Letters to the Editor

The Author Response: A Case Study on Engineering Failure Analysis of Link Chain

Fig. 1. Boundary and loading conditions of elastic stress analysis in each installation condition. (A) Correct installation condition. (B) Incorrect installation condition.

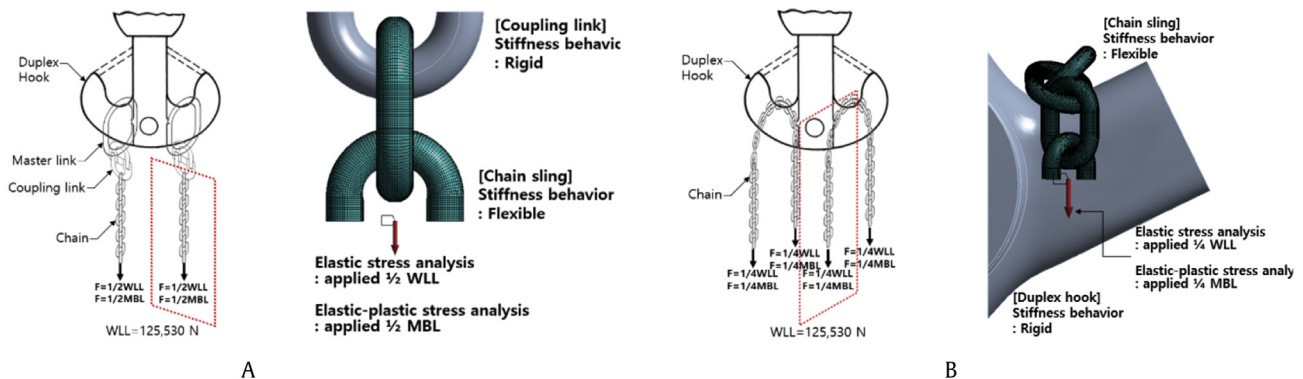
The authors thank Dr Yu for his interest in our findings on engineering failure analysis of link chains [1] and his valuable criticism of our findings [2]. We respond to his comments as follows, focusing on the content of the question (Figs. 1 and 2).

1. Response revised on FEA category in this paper: This article is written for supplementation of stress analysis parts (relatively idealised and straightforward structure, simplifying the loads and material property assumptions, etc.) for crane chain in the existing paper [1]. In material properties, an elastic material model for stress analysis, which was conducted in an existing paper, was used to re-evaluate plastic collapse due to the Working Load Limit (WLL) in each installation condition. The analysis results show that high stress (total stress) at the junction of the barrel and that of curvature of the crane chain are similar in the area where the crane chain was broken. Compared with the correct installation conditions, when high stress is applied, the incorrect installation condition evinced a breakage. For determining the membrane and bending stress components, the total stress distribution was obtained from elastic stress analysis, and linearised on stress component integrated along the cross-section of Stress Classification Lines (SCLs) through

Fig. 3. Results of elastic stress analysis of incorrect installation condition.

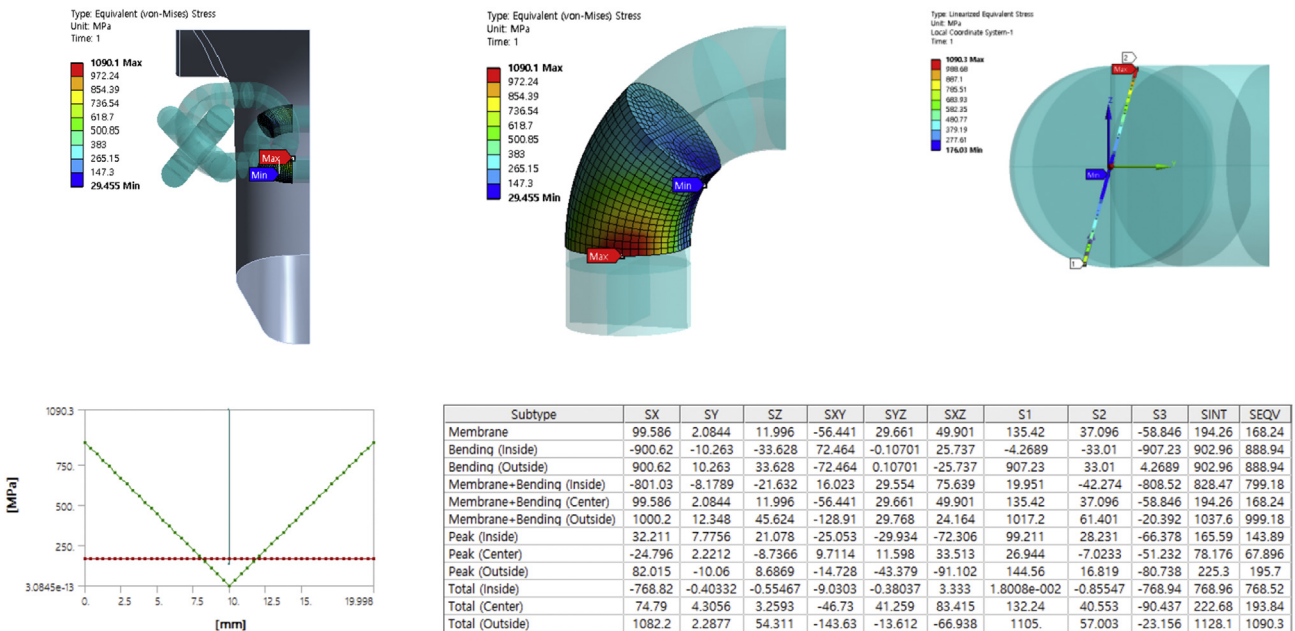
2. Additional explanation of the fractographic analysis: According to your comments on the paper, you claim that “the crack likely initiated around the chain inner surface, where the presence of high tensile stress under tension load or small stresses under bending load while a ‘crushed damage’ area was found there.” However, the crushed damage observed in the chain's inner surface cannot be formed by uniaxial tension load because the inner surface of the chain at this position was not contacted with other chains on the condition that the crane chain was installed correctly, as shown in Fig. 7 [1] A in the paper. Accordingly, we concluded that the crushed damage was possibly formed by an improperly installed crane chain inducing abnormal interlocking of the chains (Fig. 3).
